CITY OF LA VISTA
MAYOR AND CITY COUNCIL REPORT
JANUARY 20, 2026 AGENDA

Subject:	Type:	Submitted By:
APPLICATION FOR PUD SITE PLAN AMENDMENT AND PRELIMINARY PLAT LOTS 1-3 SOUTHPORT WEST	◆ RESOLUTION (2) ORDINANCE RECEIVE/FILE	CHRISTOPHER SOLBERG DEPUTY COMMUNITY DEVELOPMENT DIRECTOR

RE: Planned Unit Development, Preliminary Plat, and Final Plat – Initial Review
Southport West Replat 10

PLANNED UNIT DEVELOPMENT SITE DI AN

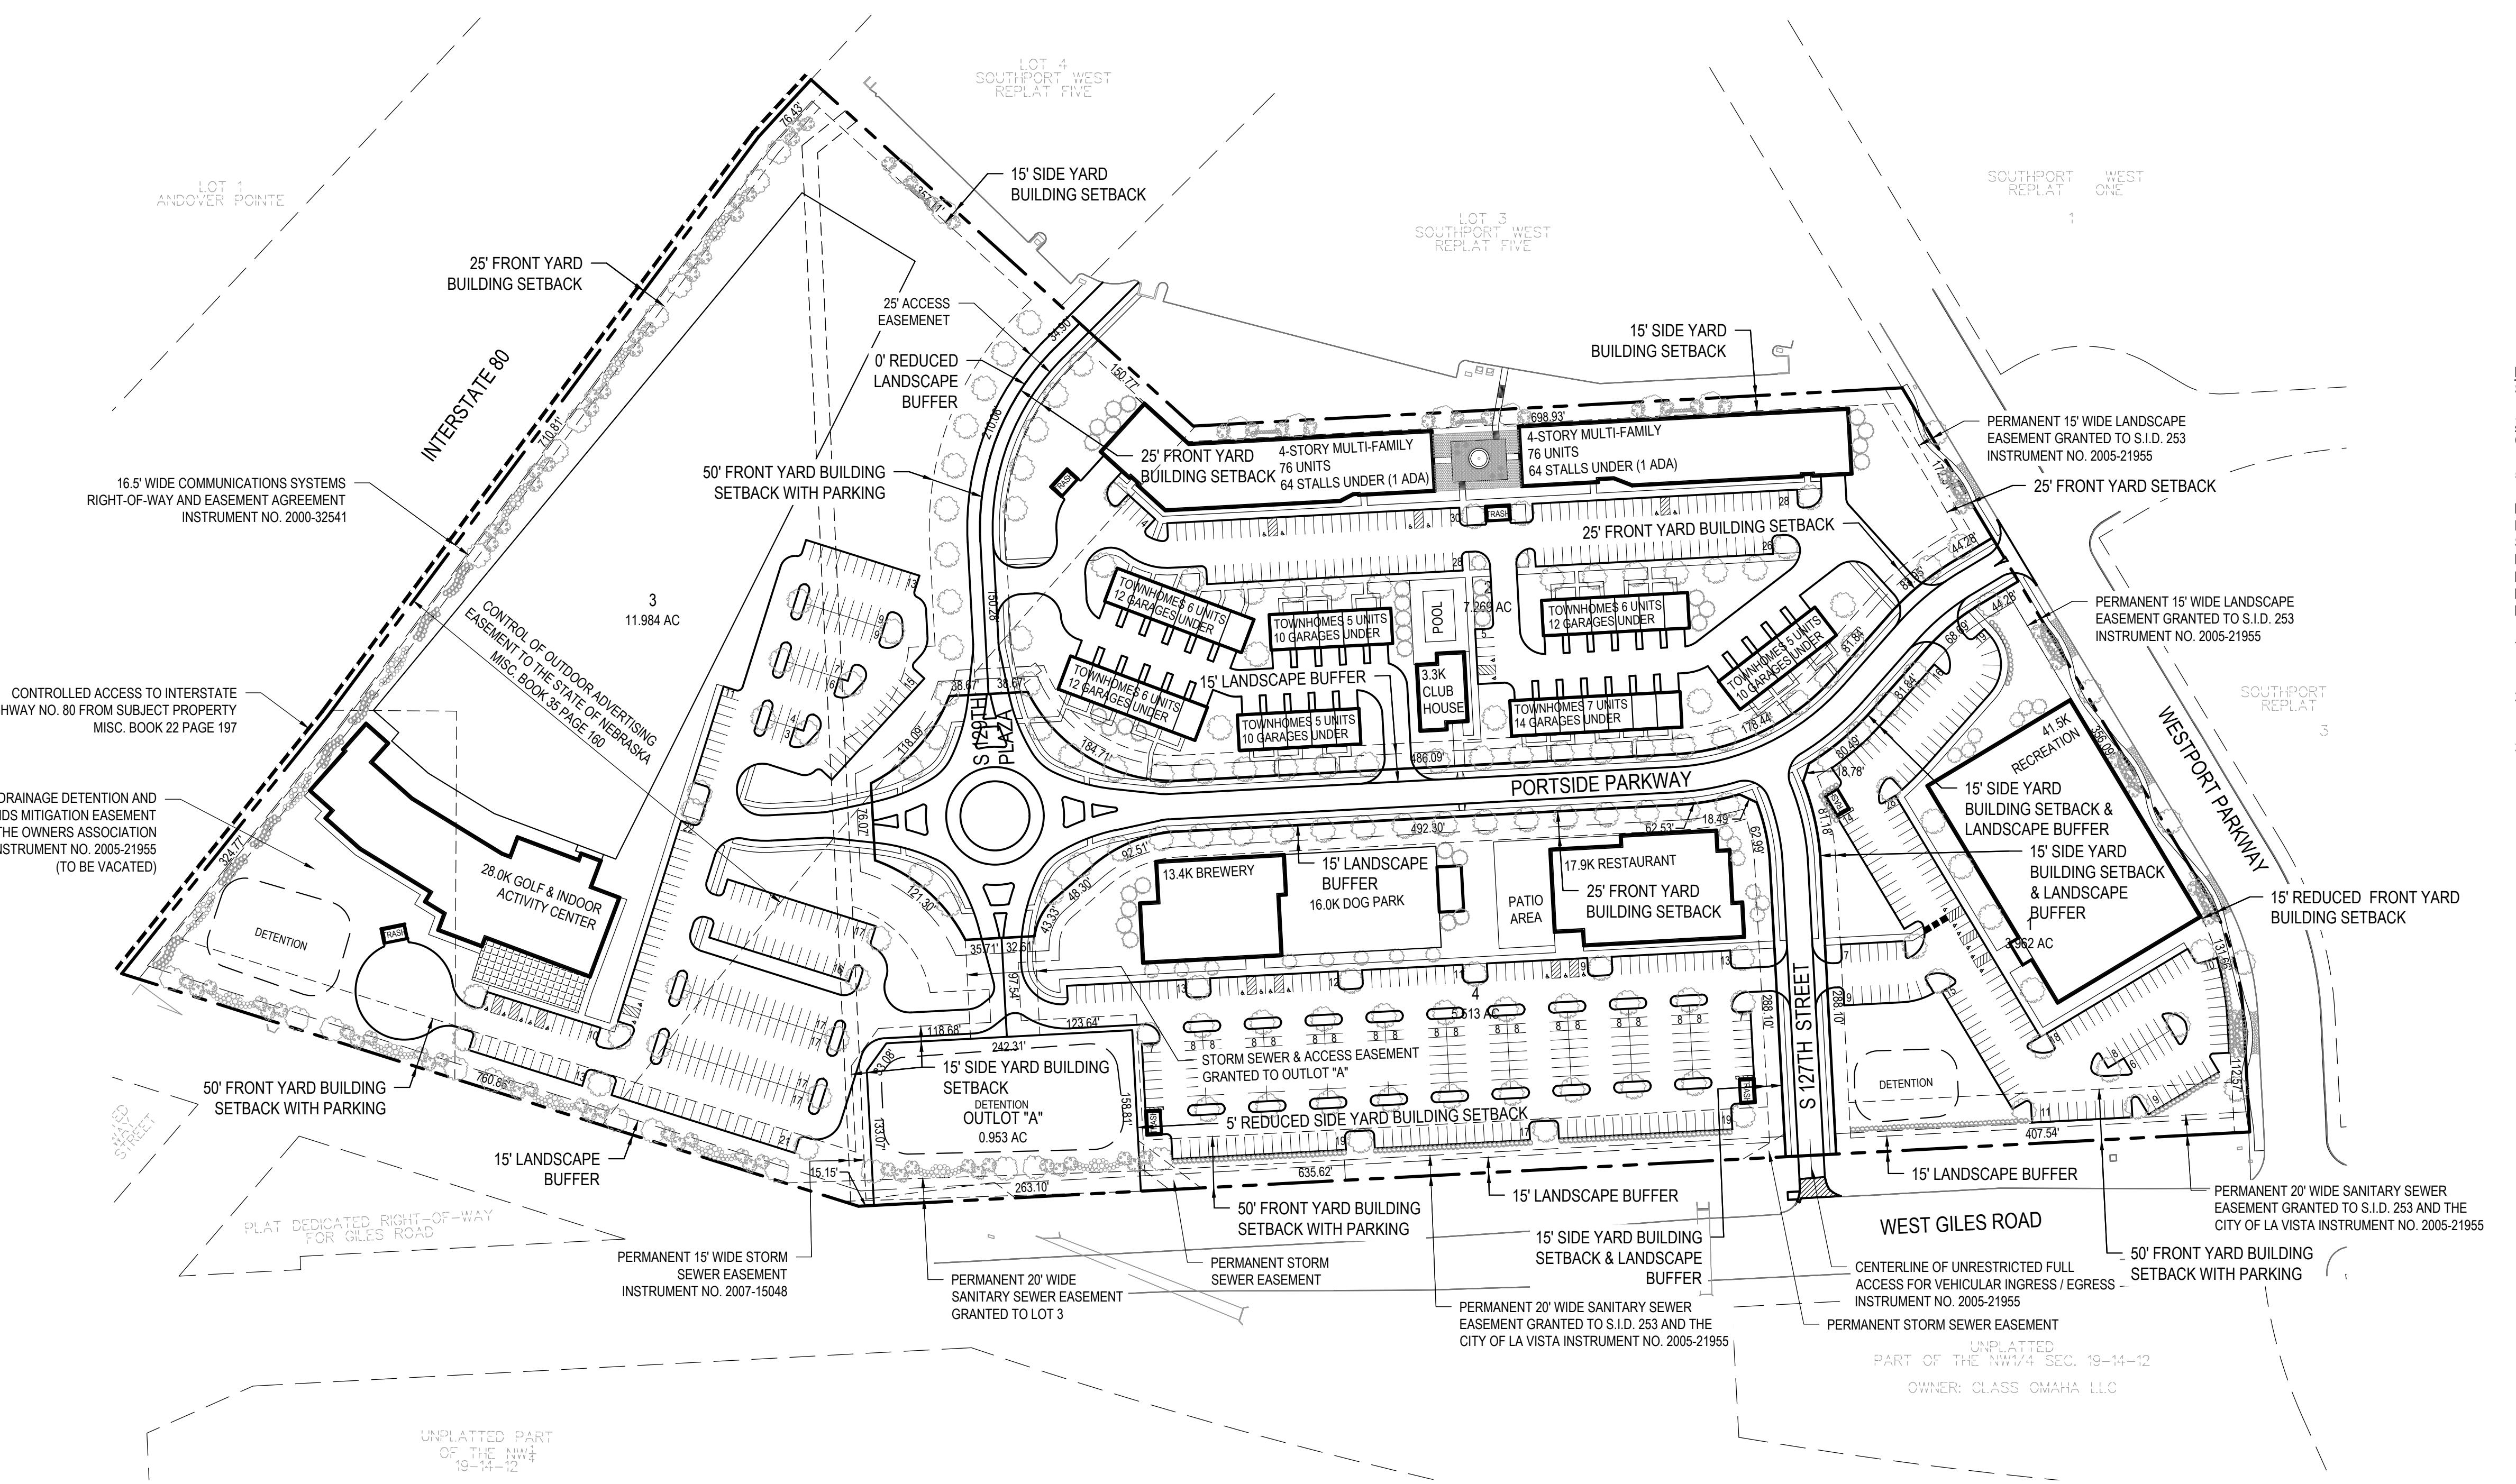
9. Section 5.15.04.08 - Adequate parking shall be provided for each building and use. For the multi-family buildings, including the townhomes, this requirement is 1 stall per bedroom. The PUD site plan demonstrates the multi-family property meeting this requirement. Regarding Lots 1, 3, and 4 and the proposed commercial developments on those properties, the Southport West PUD Ordinance requires a ratio of 4.5 off-street parking spaces per 1,000 square feet of gross leasable floor area. The proposed development on Lot 1 does not meet this required minimum. However, Lots 3 and 4 have an excess of parking above this required minimum. In order to accommodate the required parking for Lot 1, staff propose a cross-parking and access easement over the commercial properties, which will satisfy the requirement through the PUD. Such additional parking on Lot 4 would need to be constructed along with the development on Lot 1 in order to supply the minimum parking required.

10. Section 5.15.04.10 – As depicted within Article 2 of the Zoning Ordinance, the property line along Westport Parkway is considered a Front Yard. Also, the northern lot line is considered a Side Yard. Setback deviations can be authorized as per Section 8B of the Southport West PUD Ordinance. However, allowances need to be requested with adequate reasoning and depicted within the PUD Site Plan map set.

11. Section 5.15.04.11 – Maximum lot coverage varies based on the proposed use (60% for commercial, 40% for residential). Please revise the site note on PUD Site Plan accordingly.

17. Section 5.15.05.02 Subsection 3 – Although a dumpster enclosure is depicted for the development on Lot 1 Southport West Replat 10, no other dumpster enclosures are depicted within the PUD Site Plan map set. Please add sufficient enclosures to handle the waste anticipated. Additionally, please propose an alternative location for the dumpster enclosure on Lot 1 to ensure that it is not located along Westport Parkway.

Response: A Cross Parking Easement note has been added to the Plat and the PUD Site Plan.

Response: The setback notes have been updated on the PUD Site Plan, and a waiver is being requested to reduce the front yard setback along Westport Parkway. This reduction, for Lot One and the building's placement, is intended to improve pedestrian access to the building from both Portside Parkway and Westport Parkway.

Figure 4

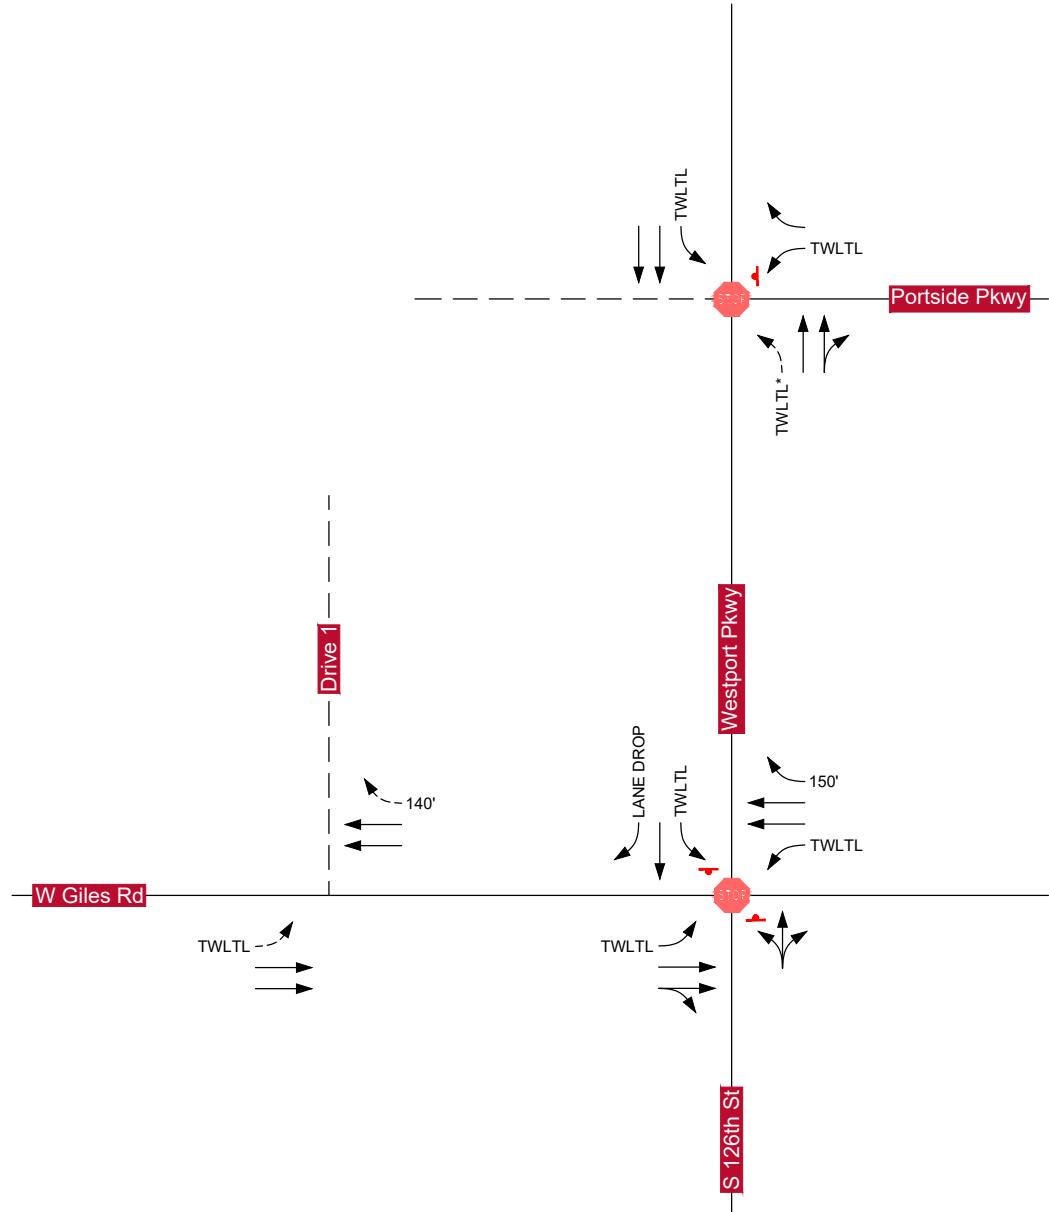
1. Existing Section, Page 1, Figure 4: Several of the stop-controlled northbound and southbound movements at the intersection of 126th Street/Westport Parkway with West Giles Road currently operate at LOS E or F during the study peak hours. LOS E or F operations are not uncommon for stop-controlled side street movements during peak hours.

Figure 9

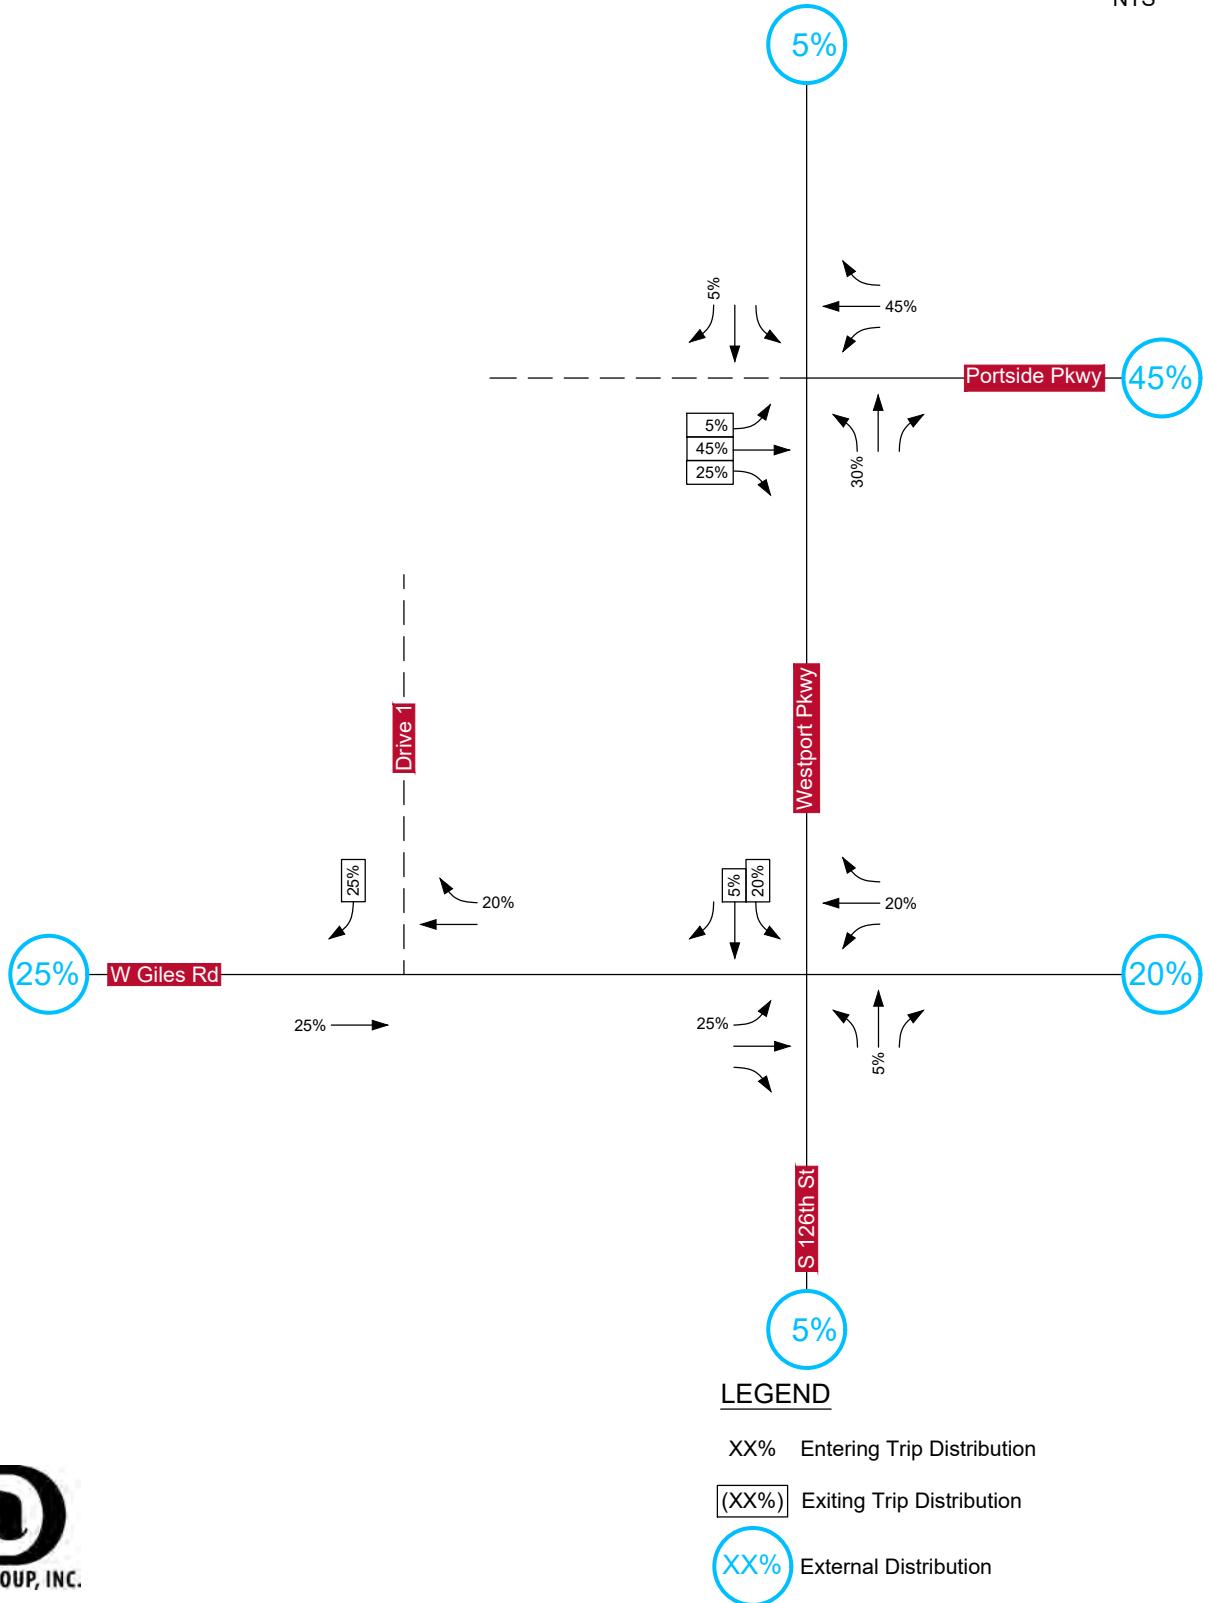
4. Site Section, Page 2, Figure 9: The memo refers to the ITE Trip Generation Manual 11th Edition and provides expected site trip generation volumes for daily and peak hour time periods.
